Re: Atlantic Coast Pipeline/Docket Nos. CP15-554-000 and CP15-554-001

Ref. # Docket No. CP15-554-000 and CP15-554-001

We would like to take this opportunity to raise concerns specific to the GWNF 6 Alternative. The Board understands that the George Washington and Monongahela National Forests requested a reroute to protect the Cow Knob Salamander. While FERC had requested a "southern" route, Atlantic Coast Pipeline is proposing a route that goes south through Highland and Bath Counties, Virginia and then abruptly turns north once more running approximately 20 miles to rejoin the original route along Route 250 in western Augusta County. Map 1 depicts the GWNF 6 Alternative in sharp contrast to the southern route proposed as part of Figure 10.8.1-2 from Resource Report 10 filed by Atlantic Coast Pipeline as part of their review process. This proposed route runs in the opposite direction of its destination in North Carolina. The impact of this proposed reroute was an increase from 141 miles in the Atlantic Coast Pipeline filed route to 170 miles using the GWNF 6 Alternative. What possible reason can Atlantic Coast Pipeline have in rejoining the original route in western Augusta Count

MAP 1
Proposed Atlantic Coast Pipeline
GWNF-6 Alternative Route
4/12/2016

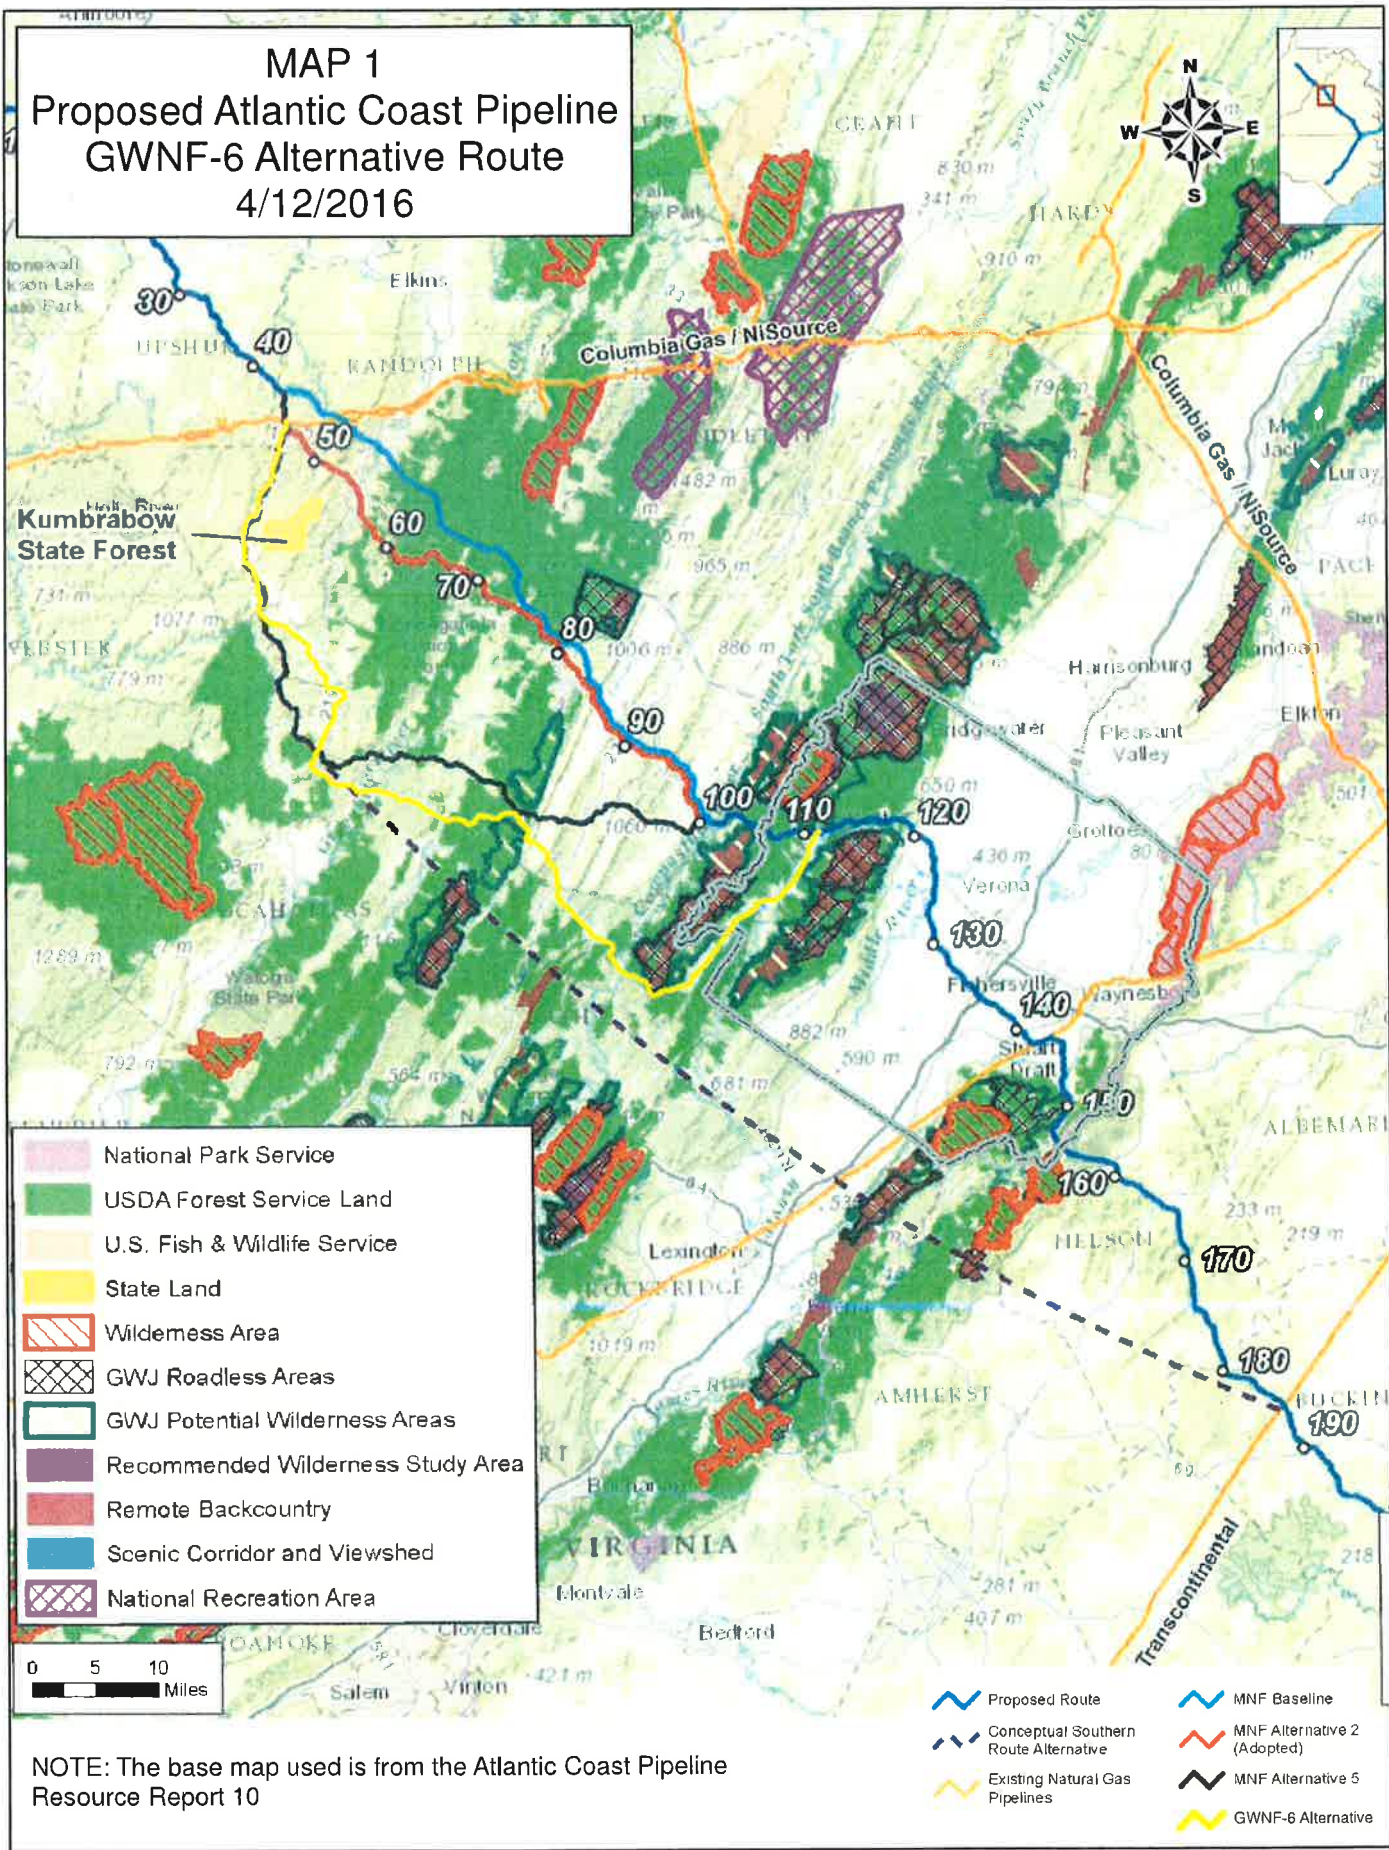
Finally, the question has to be asked is the GWNF 6 Alternative even what was asked for by FERC? The USFS asked Atlantic Coast Pipeline to protect the habitat of the Cow Knob Salamander. FERC asked for a southern route. Atlantic Coast Pipeline submitted a route that simply got around the salamander habitat and quickly rejoined the original route. They didn't really even consider a southern route. The Augusta County Board of Supervisors does not believe that the requirements of FERC to study a southern route have been met. Is a southern route possible? Augusta County would suggest that there are multiple southern routes possible. Included in our comments is Map 3 showing only one such route which continues the proposed GWNF 6 Alternative to the east approximately 29.5 miles before rejoining the original Atlantic Coast Pipeline filed route at Mint Springs enabling the crossing of Interstate 81 to remain in its original location. This "southern" route is approximately 15-16 miles shorter than the existing alternative. Are there other, potentially better, southern routes that would protect the Cow Knob Salamander and other equally important environmental features? Is there a route that also avoids the Appalachian Trail and Skyline Drive crossing? The Augusta County Board of Supervisors would submit yes, but Atlantic Coast Pipeline chose not to study anything other than the bare minimum to address the USFS concerns.

Map 2 Proposed Atlantic Coast Pipeline GWNF 6 Alternative Floodplain and Conservation Easements

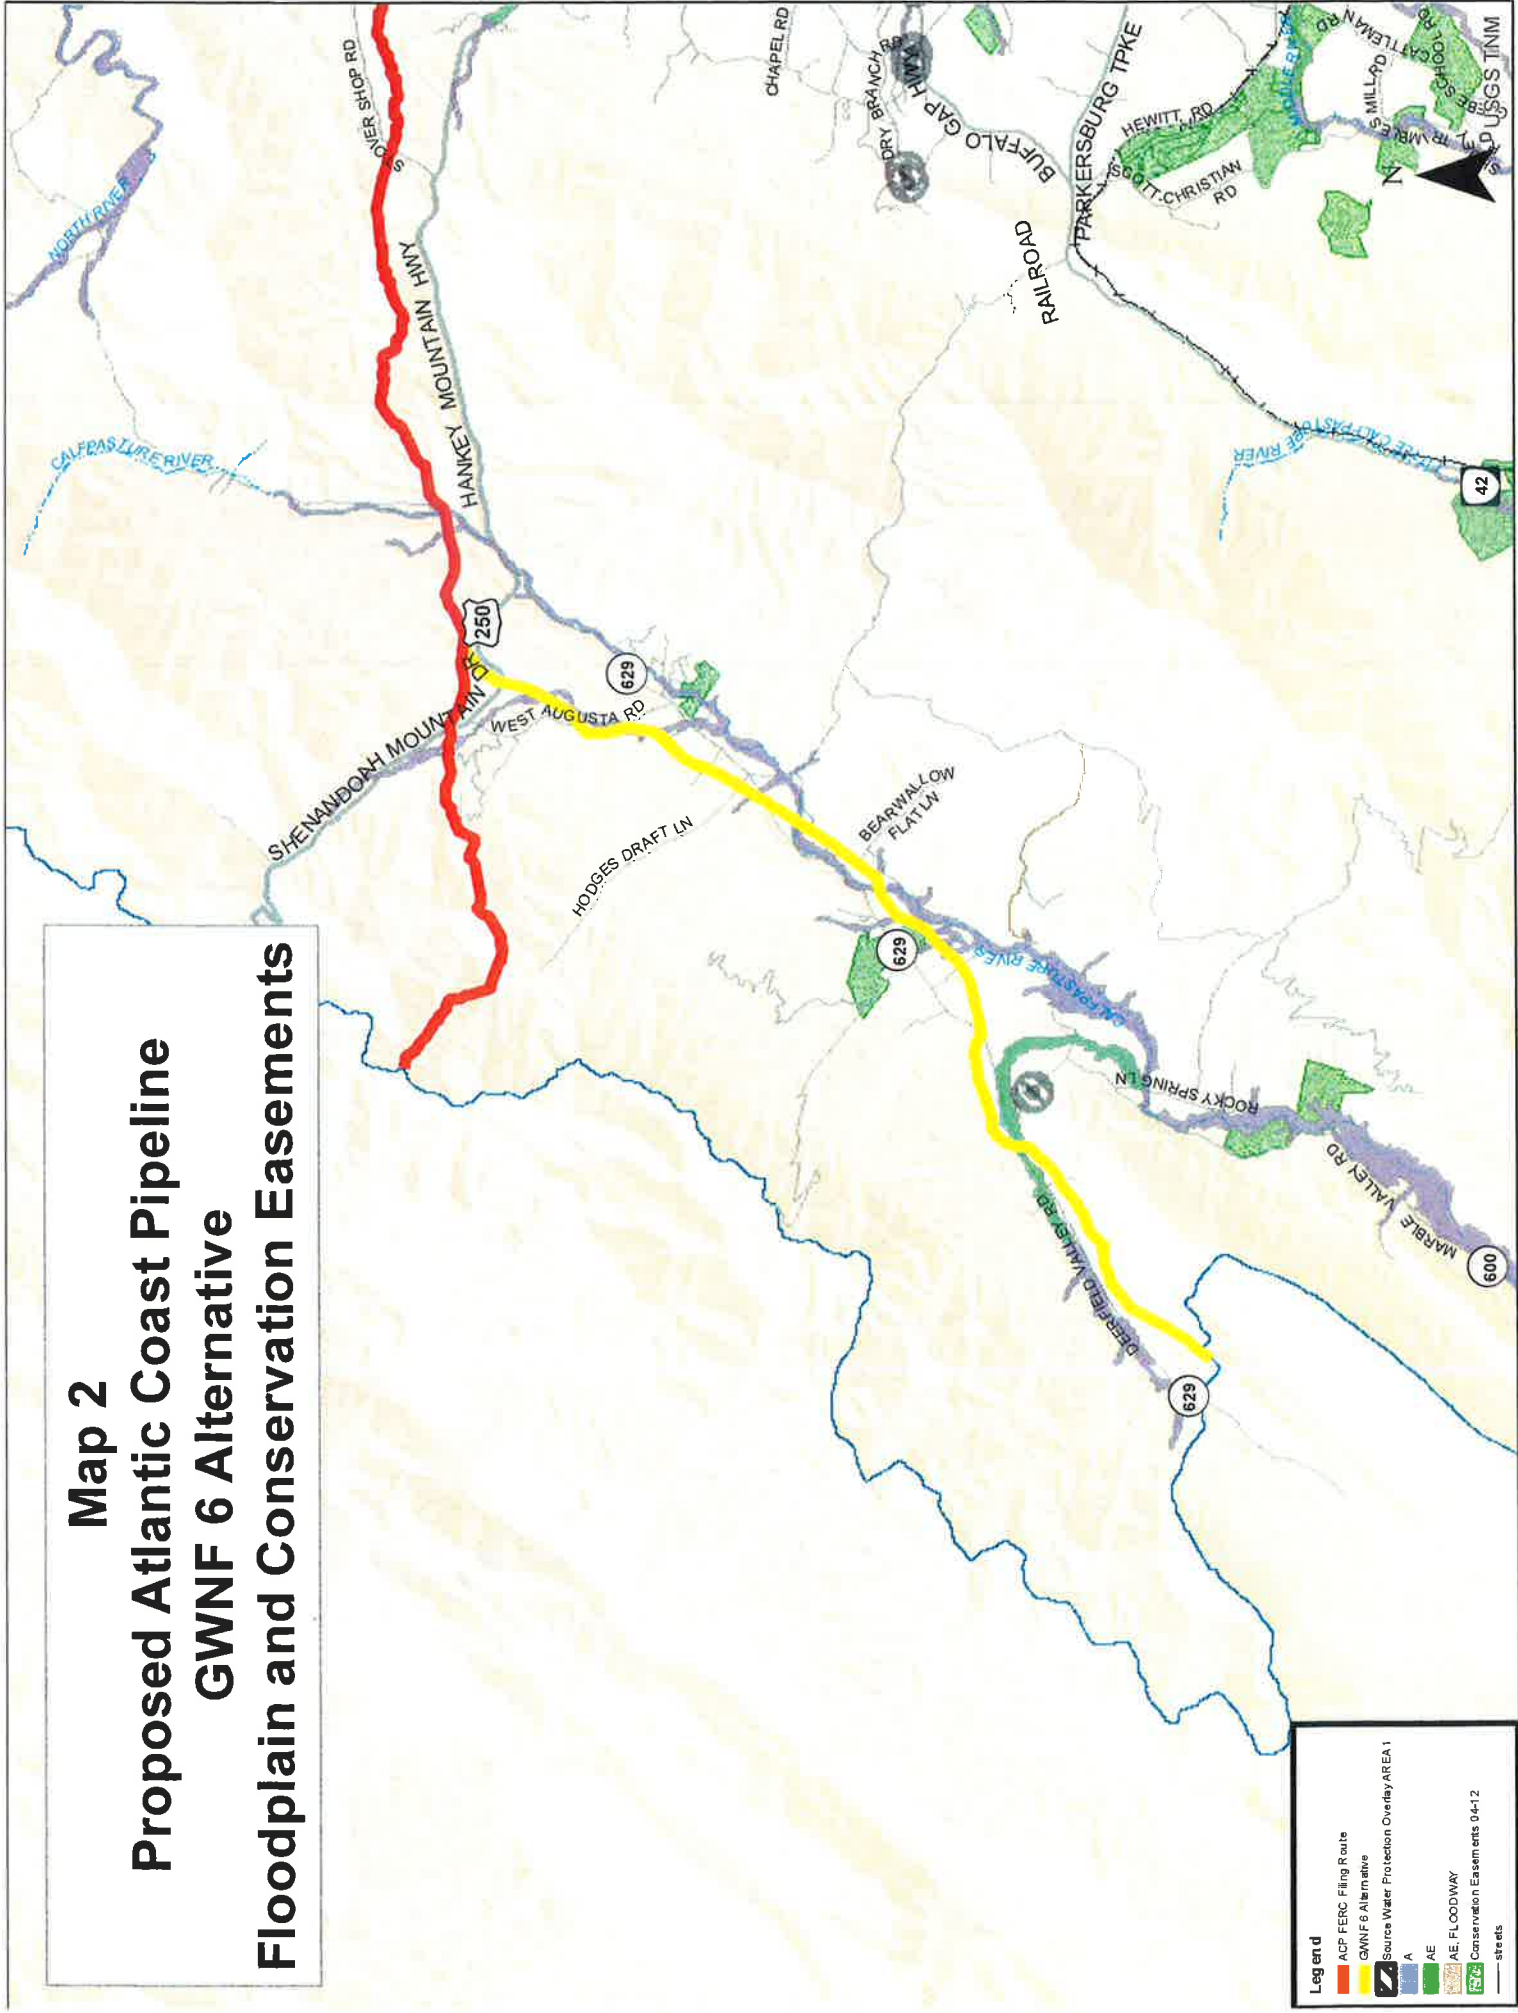
This proposed new route has significant environmental impacts. Map 2 is a detailed map of the County showing the environmentally sensitive areas associated with the GWNF 6 Alternative pipeline route, as currently proposed by Atlantic Coast Pipeline. This route crosses the floodplain in eight different places. It also impacts lands protected with conservation easements. It runs adjacent to the Deerfield wells, our public water sources in the community. The County has begun a systematic identification of the recharge areas around each well that is a source of public water and establishing Source Water Protection Areas for the recharge areas. While the delineation study is not yet complete for the Deerfield wells, it is expected that portions of the pipeline route will be in a Source Water Protection Area 2 in the future. A previous letter from the Augusta County Service Authority indicated to you, that natural gas pipelines are not permitted in areas that are zoned in a source water protection area overlay district. For that reason, we ask that FERC consider the detrimental effect the proposed pipeline will have on our efforts to protect the source of our safe drinking water.
